Transport Impact Assessment Addendum

Mixed Use Development Planning Proposal
1 Leicester Street, Chester Hill

Ref: P1007r03
26/05/2020

This TIA Addendum has been prepared to address the Conclusions and Recommendations detailed in the Peer Review as identified in **Table 1**.

Figure 1: Indicative Concept Plan

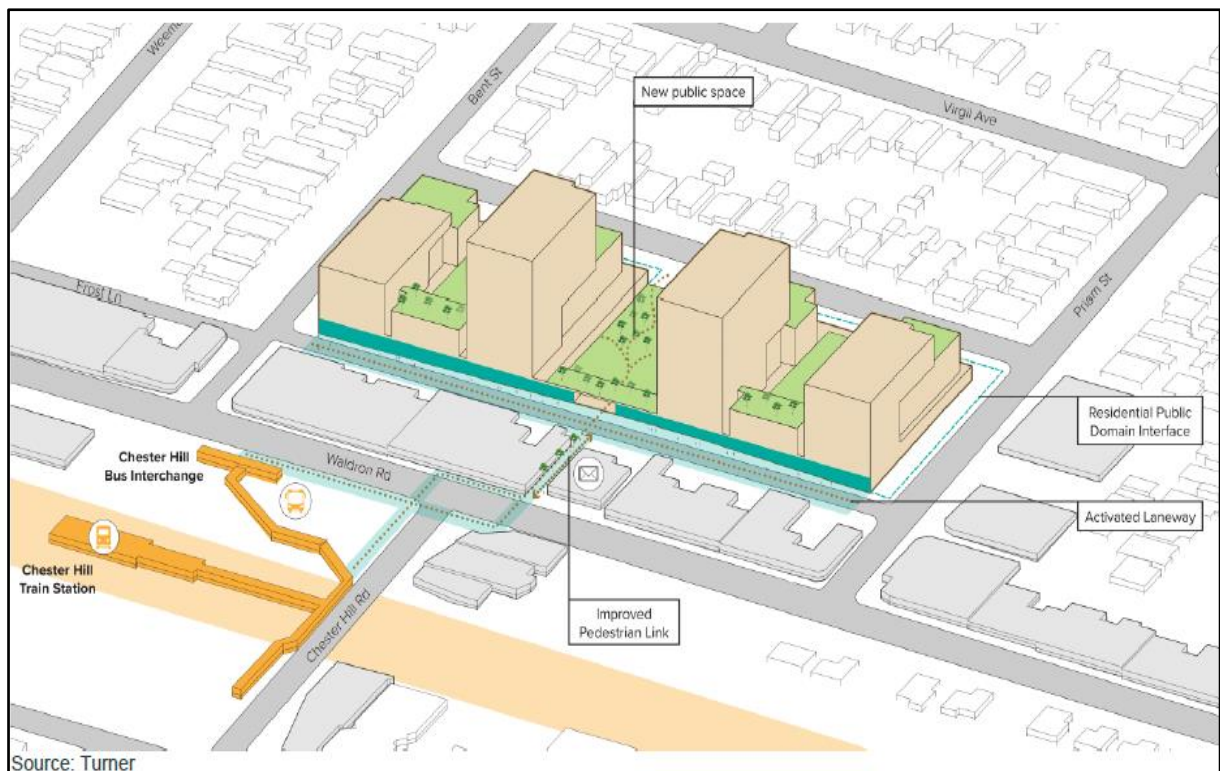
10	Modelled mitigation measures for the Priam Street/ Waldron Road do not align with Transport for NSW requirements for signalised intersections.	Section 7.2
11	Preliminary SIDRA modelling indicates that with upgrading of the Priam Street/ Waldron Road intersection and lengthening of turning bays, the additional traffic generated could potentially be accommodated on the surrounding network, subject to clarification of the above concerns and recommendations.	Section 7.2
12	While the intent of Waldron Road pedestrianisation concept recommended in the Place Design Group Urban Design Review of the Planning Proposal is acknowledged, the recommendation does not align with the intended function of Waldron Road and further detailed analysis such as microsimulation traffic modelling would likely be required to support such a proposal.	Section 7.2
13	It is recommended the location of the access points be further refined to better understand the likely traffic distribution of traffic around the site.	Sections 3 and 6.1

The original Concept Plan provided for the removal of all existing access driveways to the adjacent local roads, consolidated into one access driveway on Bent Street. The assessment provided in the sections below indicates that an additional access point on Priam Street is feasible and will be required to accommodate future Site traffic demands in conjunction with Council's vision for the area. It is anticipated that the design and location of these access points would be further examined as part of a future detailed Development Application (DA).

Figure 8: Waldron Road - SIDRA Modelling Intersection Layouts (Existing)

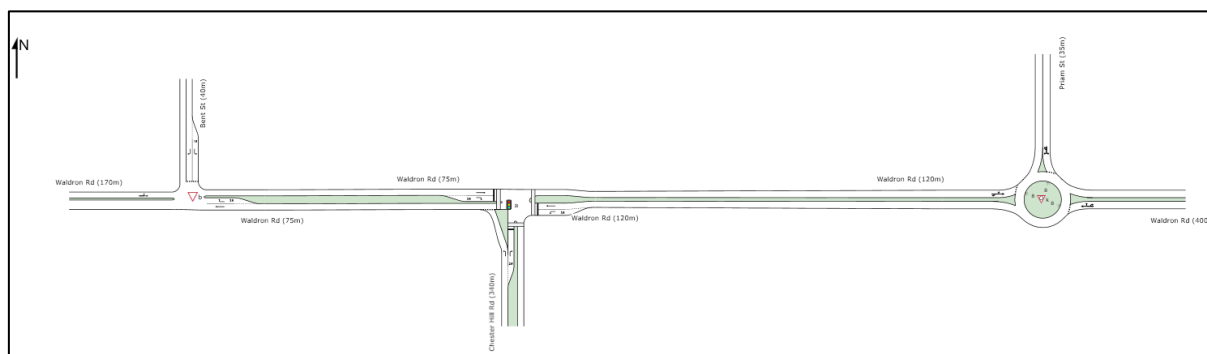
SIDRA modelling for the existing scenario has been revised by adopting the left turn slip lane from Chester Hill Road as the primary lane and the right turn lane as a 25-metre short lane, as advised in the TIA Peer Review.

Figure 11: Revised Development Traffic Distribution - Weekday AM Peak

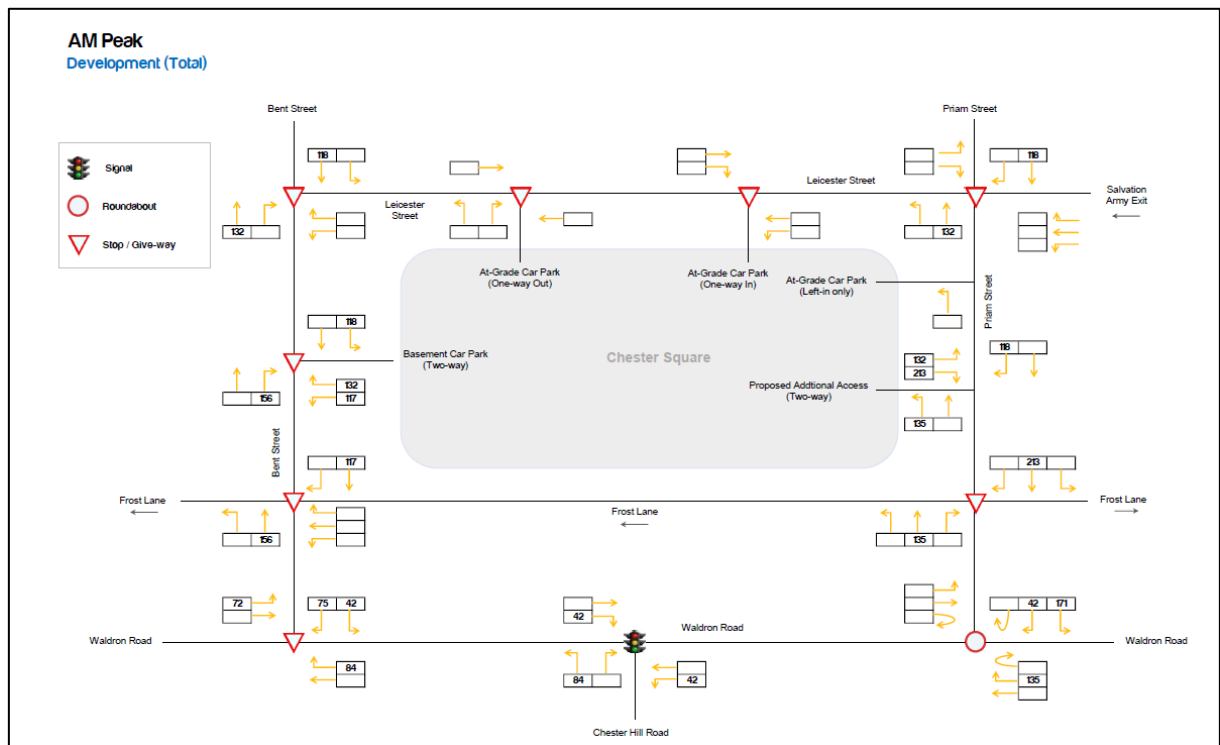
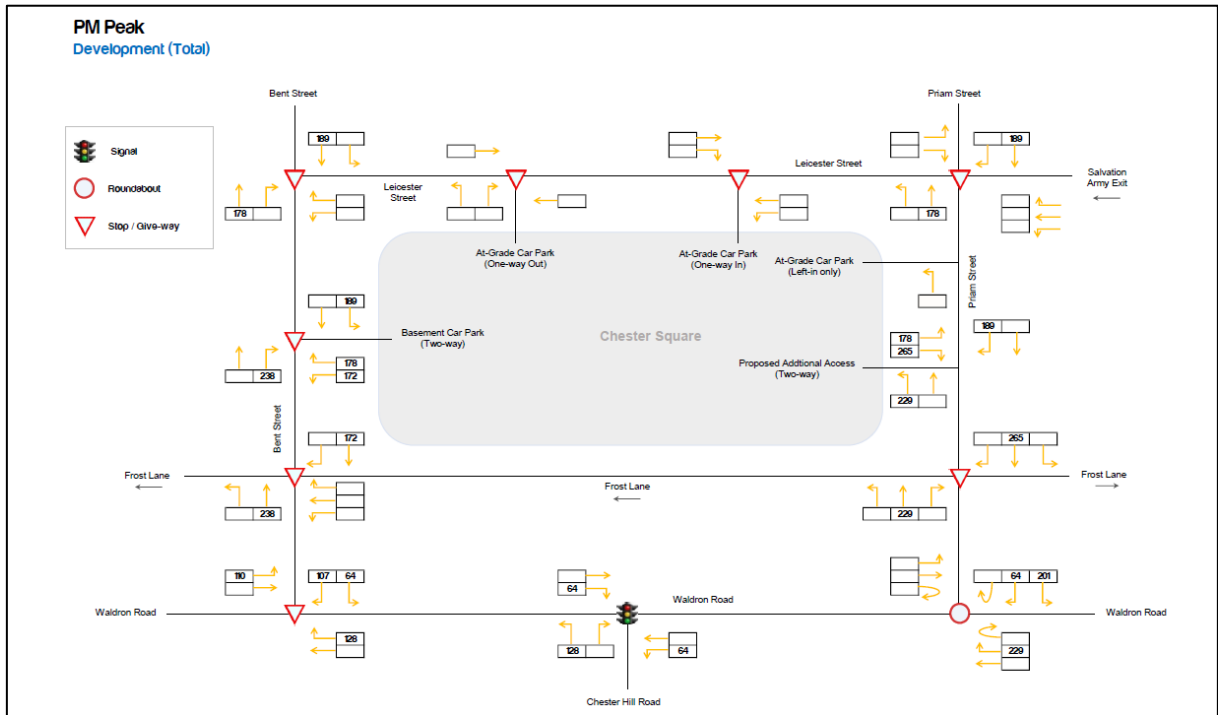
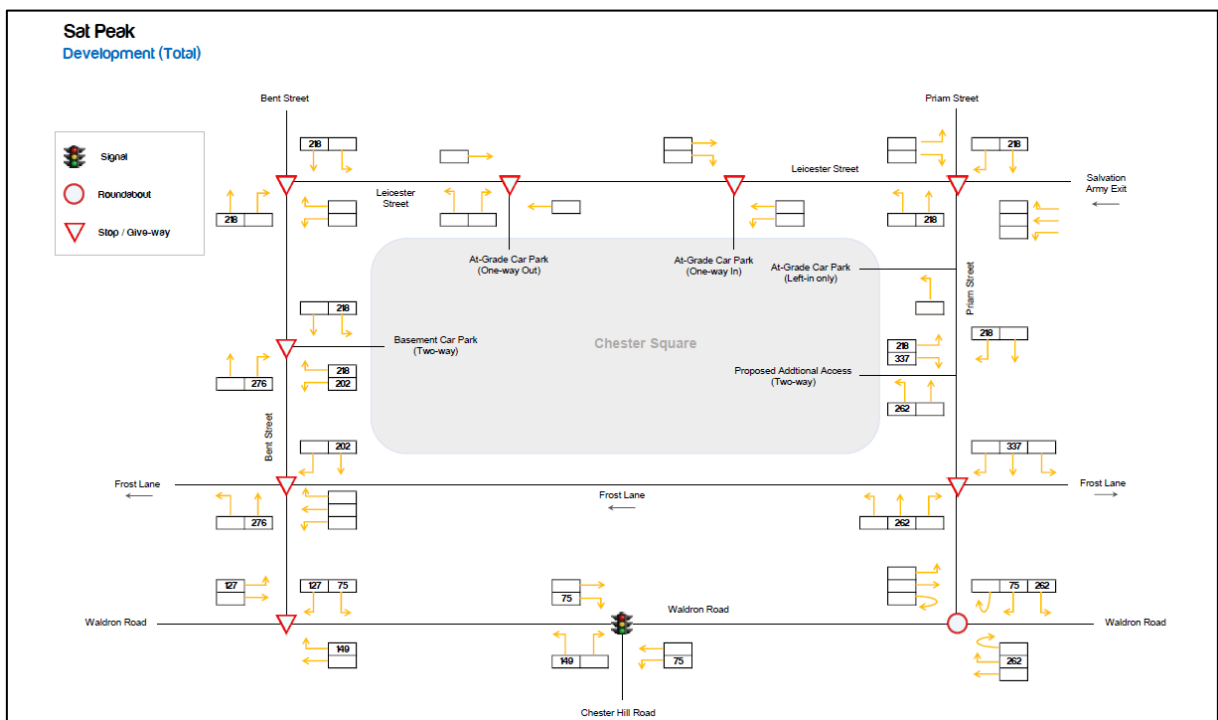
5	It is recommended that the anticipated distribution of traffic be updated to reflect the existing distribution of traffic at the key surveyed intersections.	Section 5
6	While it is recognised that the project is at a Planning Proposal stage, the indicative location and quantum of site accesses and supporting traffic modelling does not seem to provide an appropriate level of detail to adequately assess the traffic impact of the Planning Proposal.	Section 5
7	It is unclear how “2021 without development” traffic volumes were calculated, as it seems that some turning movements at key intersections reduce when compared with existing turning movements despite STFM data indicating increased traffic growth.	Section 5
8	Clarification should be provided as to the reason behind using 2026 STFM growth rates for calculating 2021 future traffic volumes.	Section 6.2
9	The adopted arrival and departure split of traffic for the proposed land uses is considered appropriate.	Acknowledged. No action required.

Notwithstanding, a revised traffic distribution assessment has been calculated with the following considerations:

- Use of the recommended traffic distribution for retail traffic only, being the use of existing development on-site. The Peer Review did not address the residential and commercial component.
- Use of calculated 2016 Journey to Work distribution for the residential and commercial component of the Proposal.

Based on the above, the traffic distribution shown in the figures below is considered more appropriate for reassessing development traffic.
